Request for Information (“RFI”)

Harrison, Town-Village Recreation Center Phase 2
270 Harrison Avenue
Harrison, NY 10528

RFI No.

#005

Drwg.: P-202/A-806 Spec.: N/A Area: ~~PARKING FLOOR~~

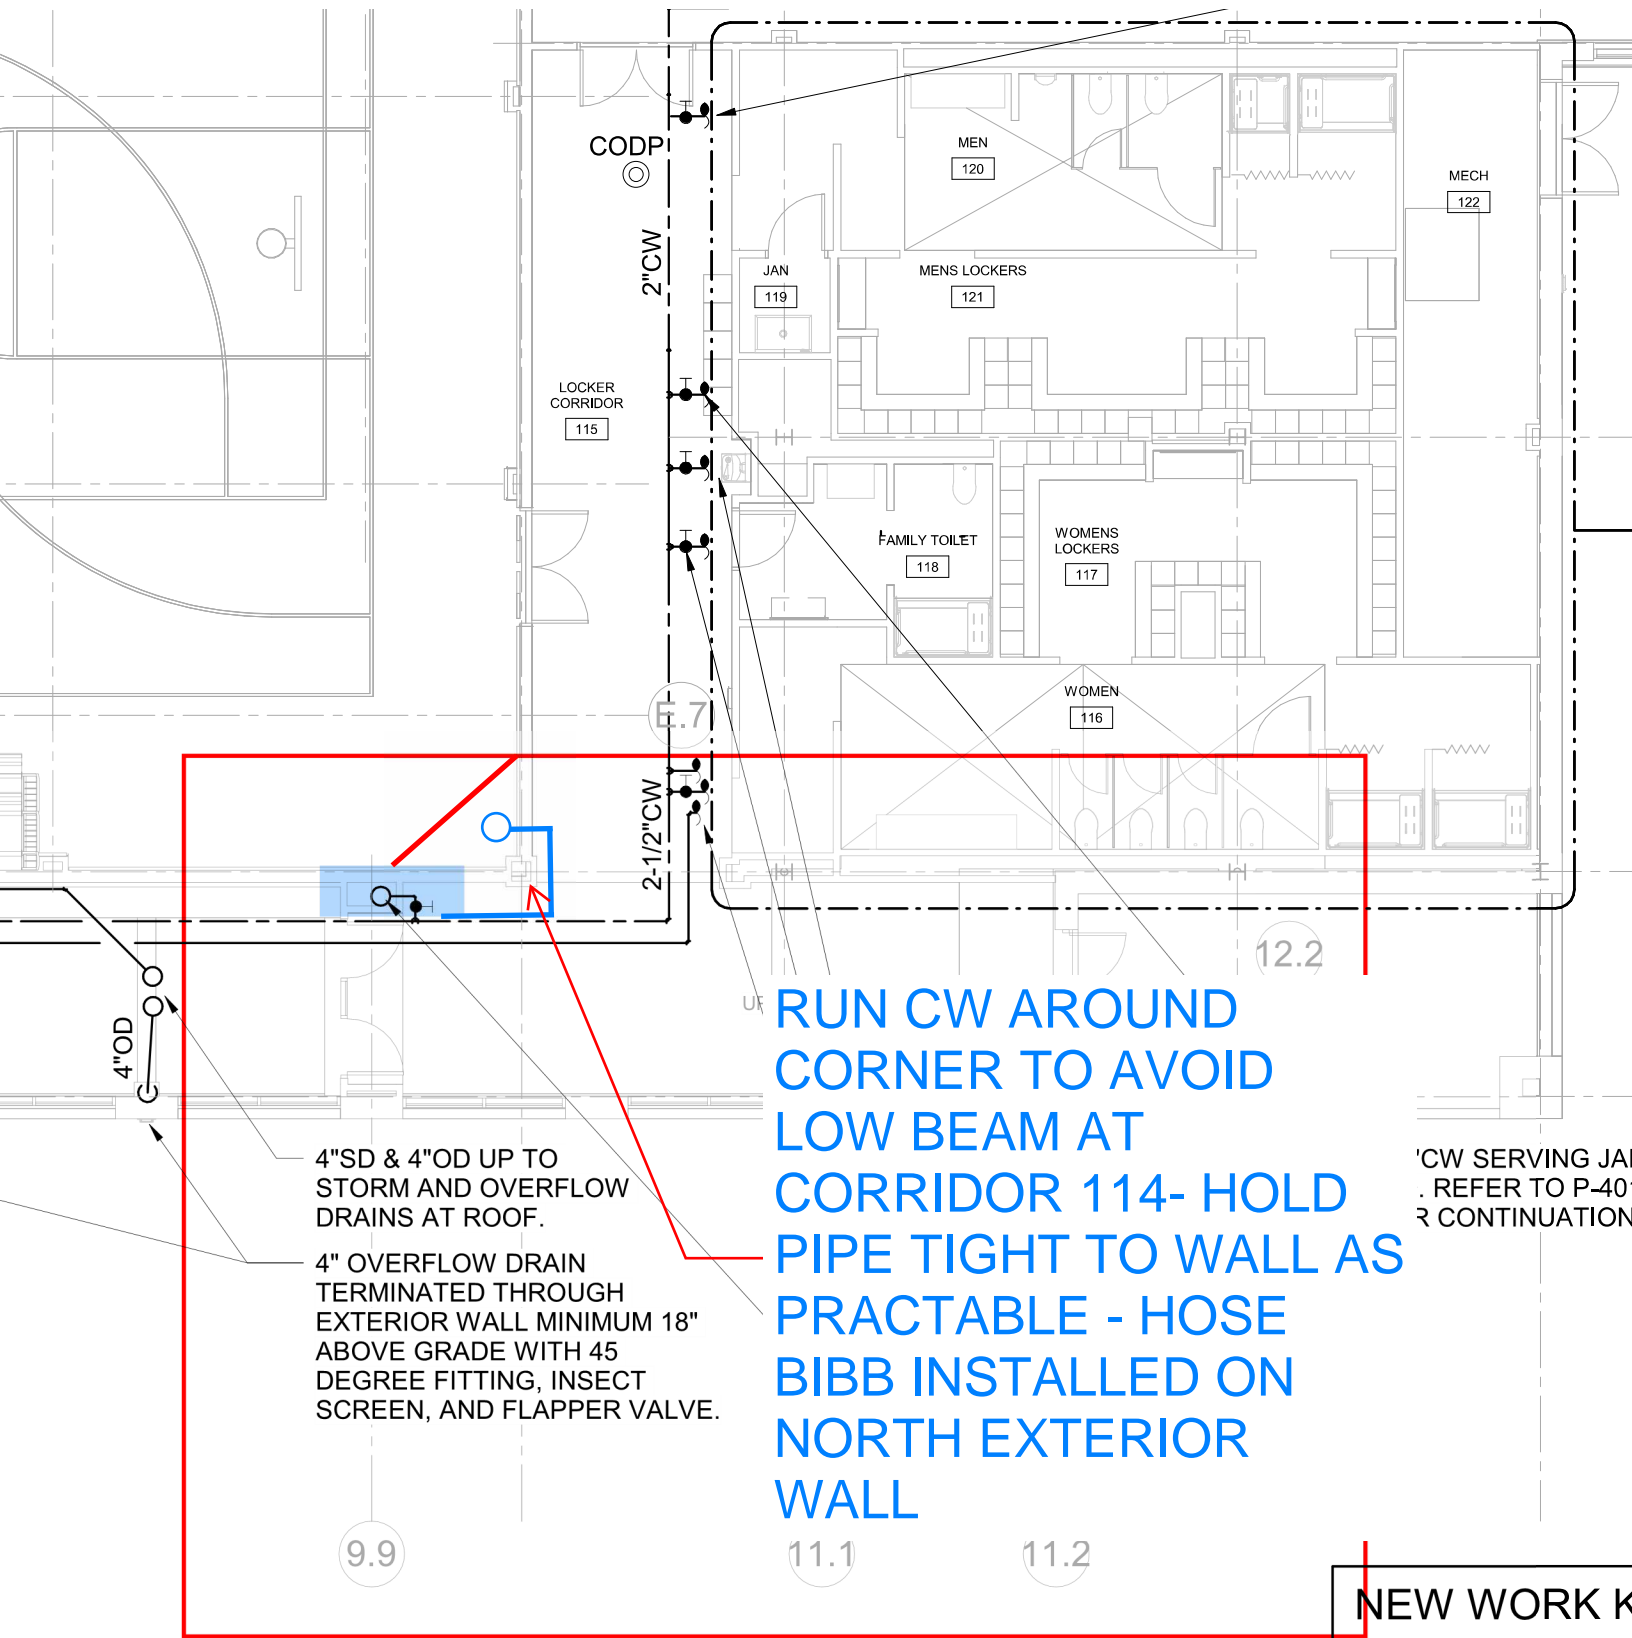
The 3/4" Non-Freeze Hose Bib near column F x 9.9 is shown directly below a steel beam. Please see the attached routing and confirm if routing through the Gym, up to a non-freeze wall hydrant is an acceptable alternative.
